Issues with old 218 PDB

designing a new power distribution board for ME218
by Joshua, winter 2026, joshua18@stanford.edu, joshuaphelp127@gmail.com

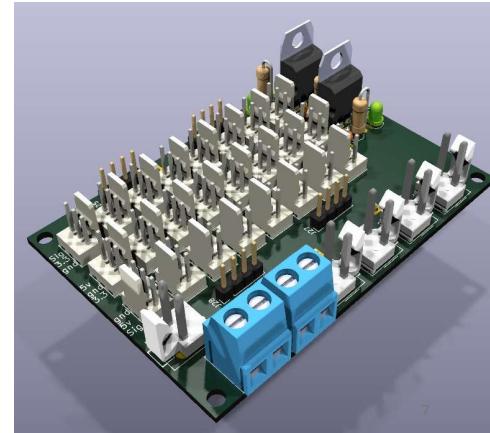
Why do switches have such low current limits?

through hole mountable ones have low limits generally

let's find switches that are rated correctly
even if it's off-board

research switches
“up-fitter switch”

design A

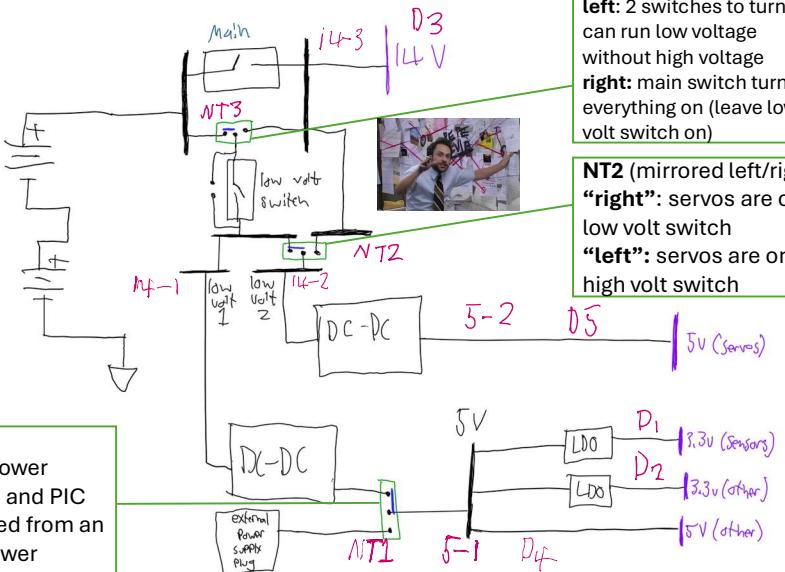
old 3 pin can't accidentally put the wrong voltage into something

3 pin connectors for everything take more board space

don't put anything on the back, make larger if needed

put voltage monitors on some of the voltage supplies?

maybe pins for adding voltage monitors

add extra capacitors to servo power bus

ground trace around servo plugs to contain the noise?

maybe servos are molex and everything else is old 3-style pintout but JST XH

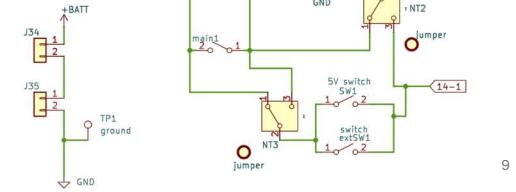
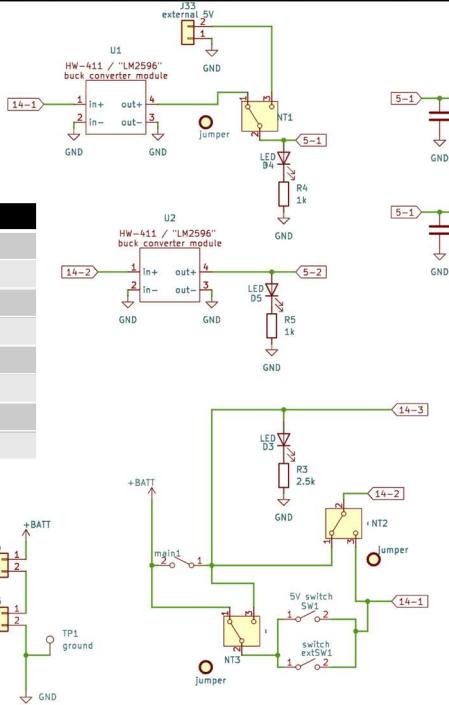
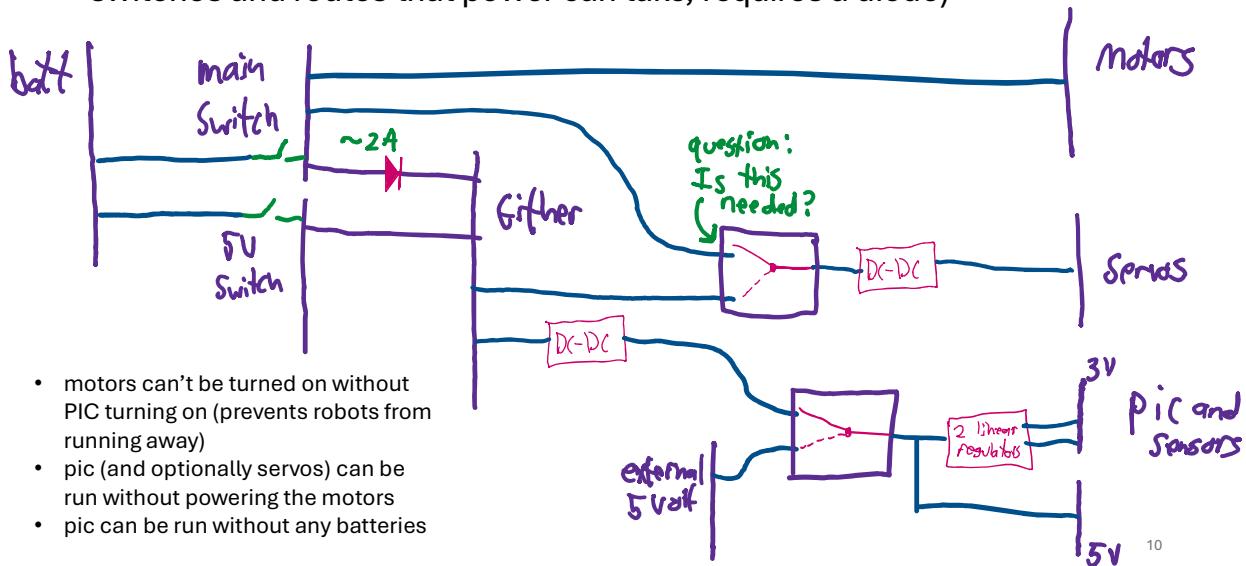
Question: do we need all these options or are we ok with removing one (maybe NT2? changing which switch controls servos might be unnecessary)

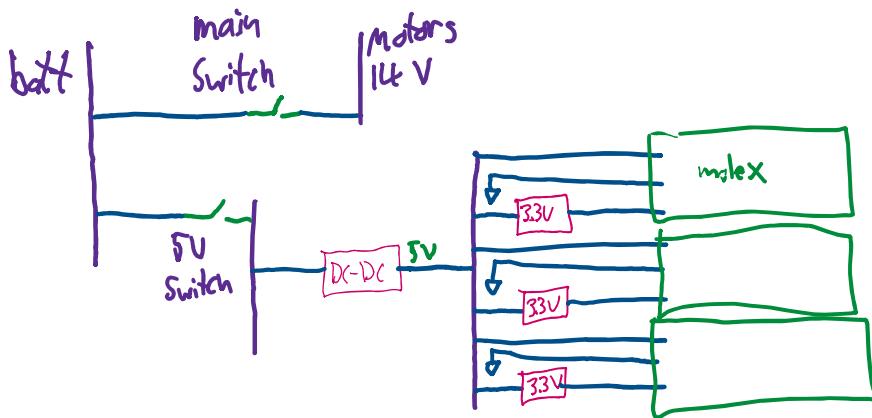
full robot shore power?

if we can find a barrel jack that has a switch to do the change over for us
